RE: **Lot 5A Block 13 S.A.D. 227 Unit 5**
6516 Jade Dr. NW
Grading and Drainage Plan
Engineers Stamp Date 3/15/2022 (E10D115)

Ernest Armijo, P.E.
Principal Engineer, Planning Dept.
Development Review Services

DRAINAGE AND TRANSPORTATION INFORMATION SHEET (REV 6/2018)

<div>ENGINEER'S SEAL</div> <div>DAVID SOULE NEW MEXICO REGISTERED PROFESSIONAL ENGINEER 14522</div> <div>3/15/22</div> <div>DAVID SOULE P.E. #14522</div>	6516 JADE COURT	DRAWN BY: WCVJ
	GRADING AND DRAINAGE PLAN	DATE: 3-15-22
	 <div>Rio Grande Engineering 1606 CENTRAL AVENUE SE SUITE 201 ALBUQUERQUE, NM 87106 (505) 872-0999</div>	20220018-LAYOUT-3-15-22
		SHEET #
		JOB # 20220018

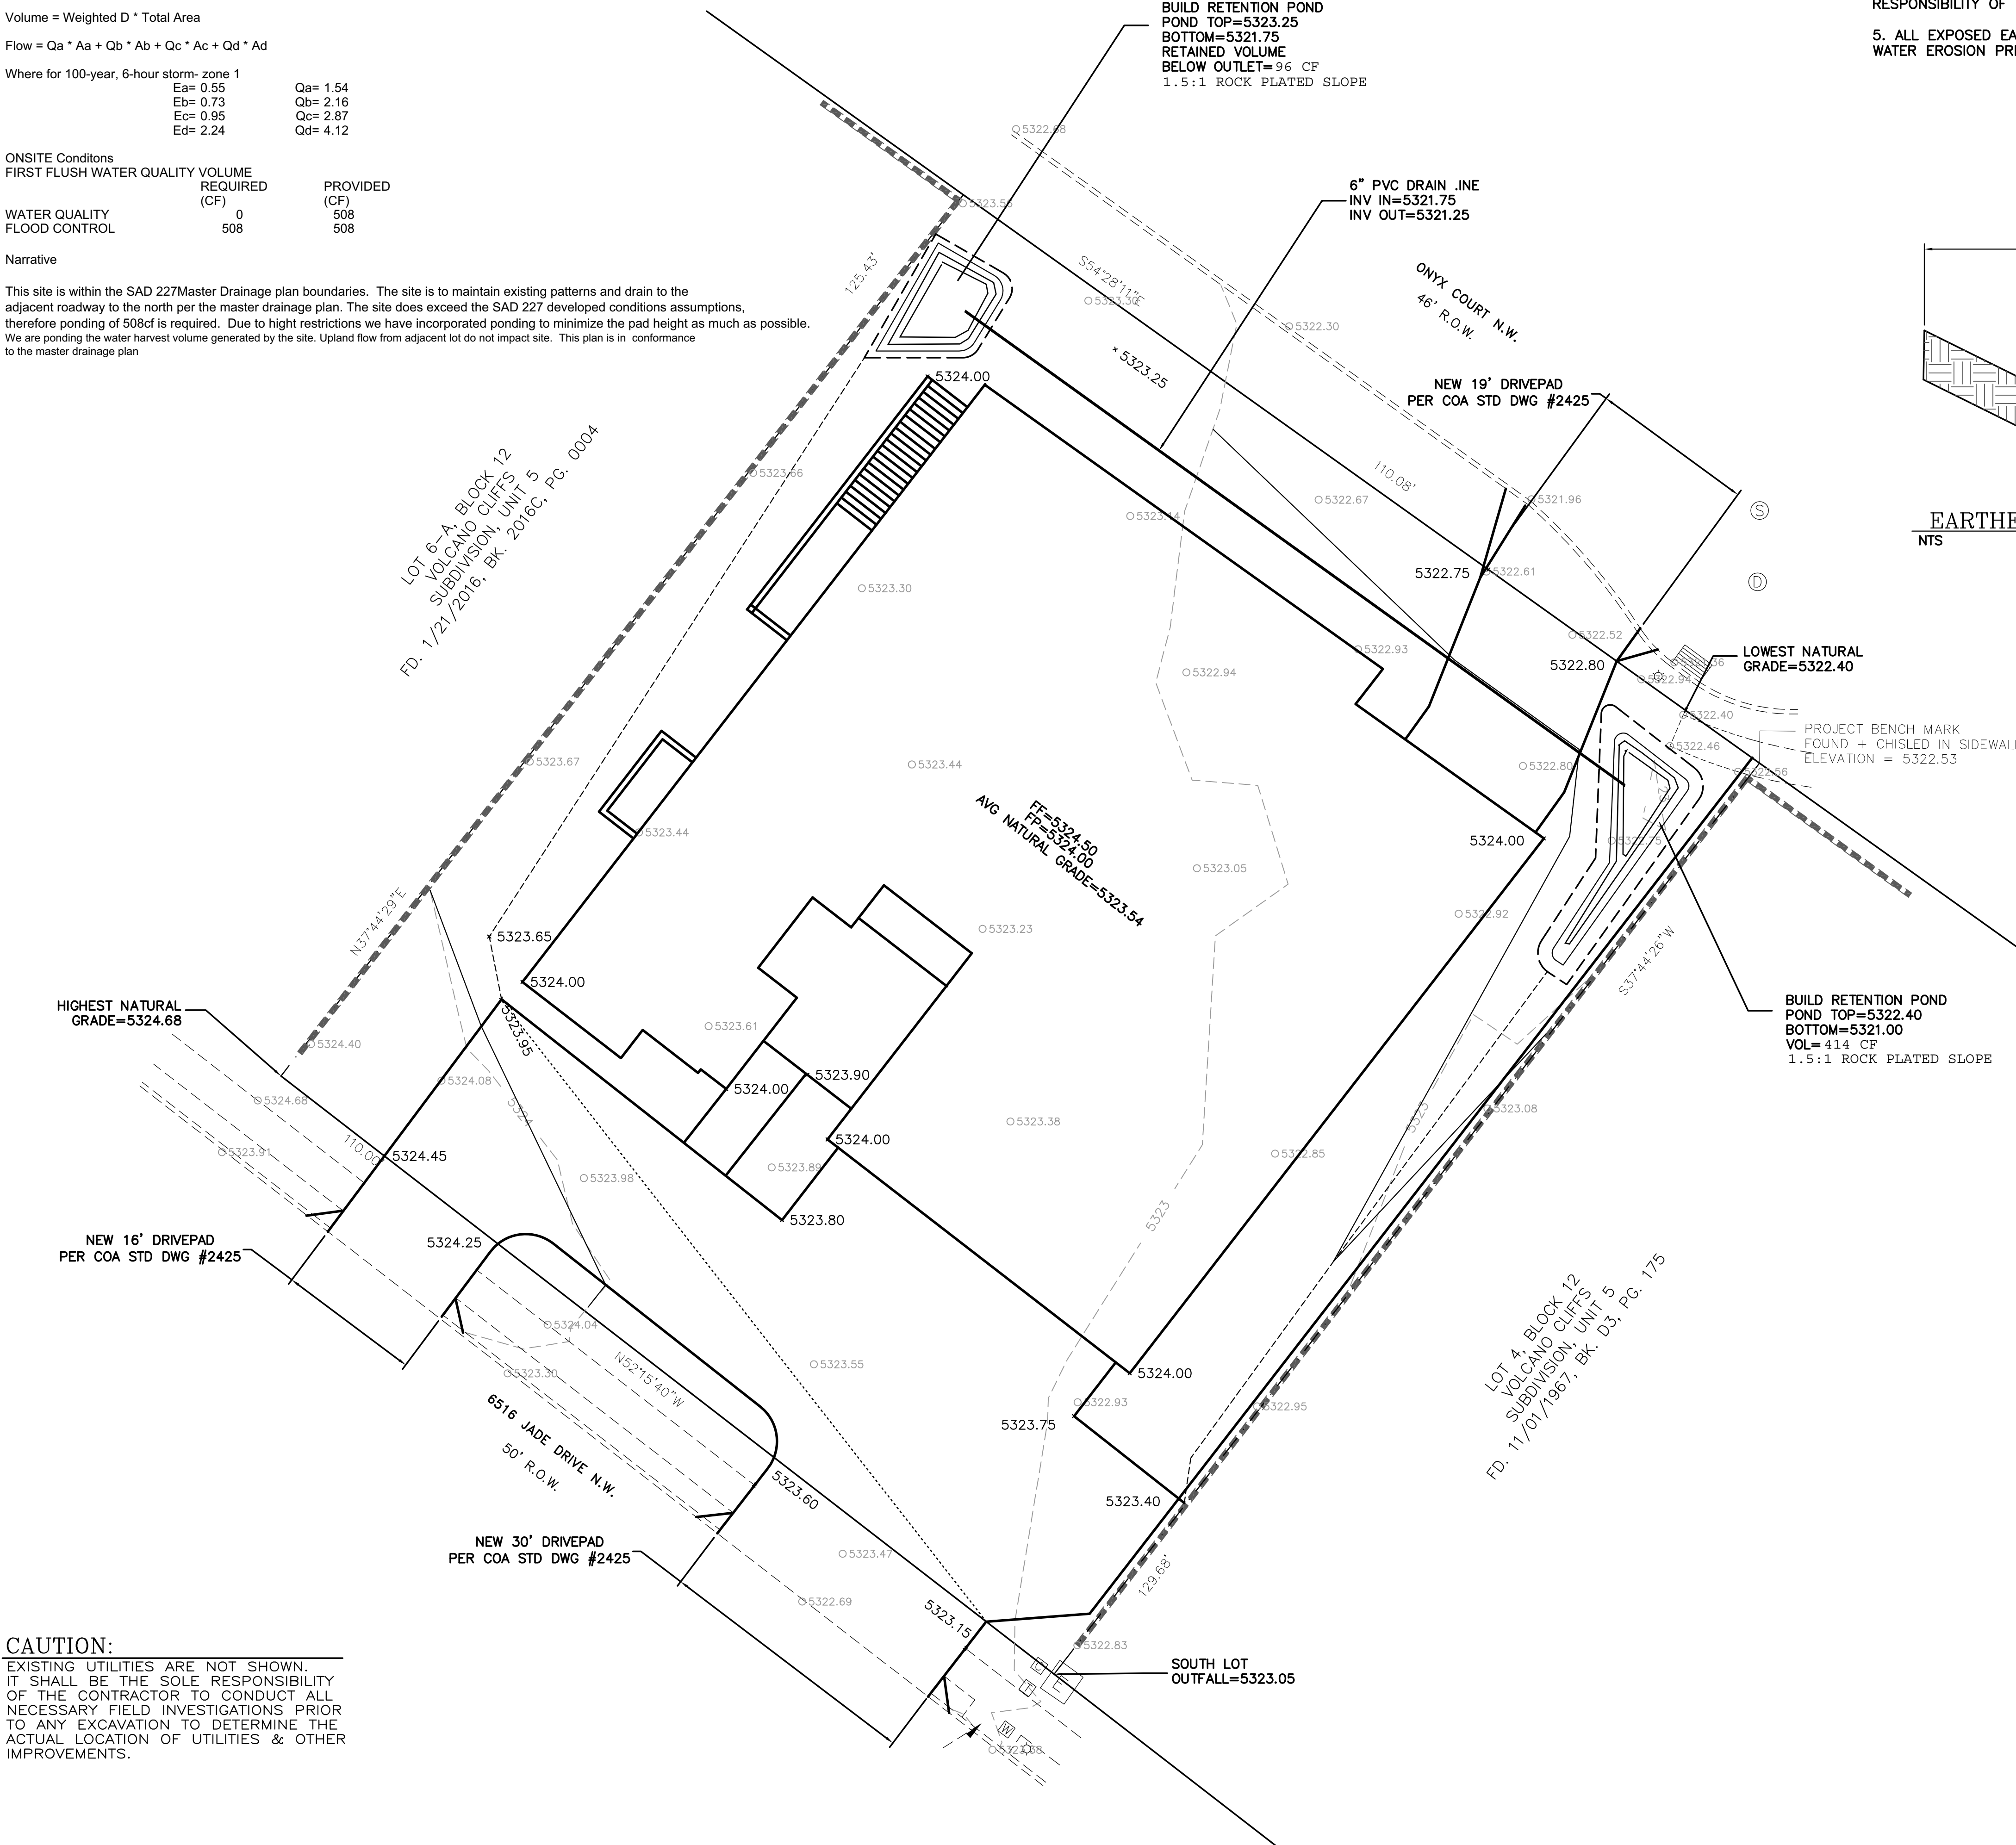
Based upon the information provided in your submittal received 1/14/2022, this plan is approved for Grading Permit. Please inform the builder/owner to attach a copy of this approved plan and letter into the construction sets in the permitting process prior to sign-off by Hydrology.

Reiterate to the Owner/Contractor that a separate permit for any garden/retaining wall must be obtained, with the approved G&D plan. Advise the owner contractor not to use dirt as a ramp to climb the curb, use lumber or crusher fines for this purpose.

Also, let the owner/contractor know that if a pool is to be added in the future the G&D plan will need to be modified showing the location of the pool and the land treatment differences.

Prior to Building Permit approval, a **Pad Certification** will be required. Inform the contractor/owner not to pile dirt in the street as a ramp to climb the curb. If dirt is found in the street the pad cert. will be denied.

Prior to **Certificate of Occupancy release**, Engineer Certification per the DPM checklist of this plan will be required.
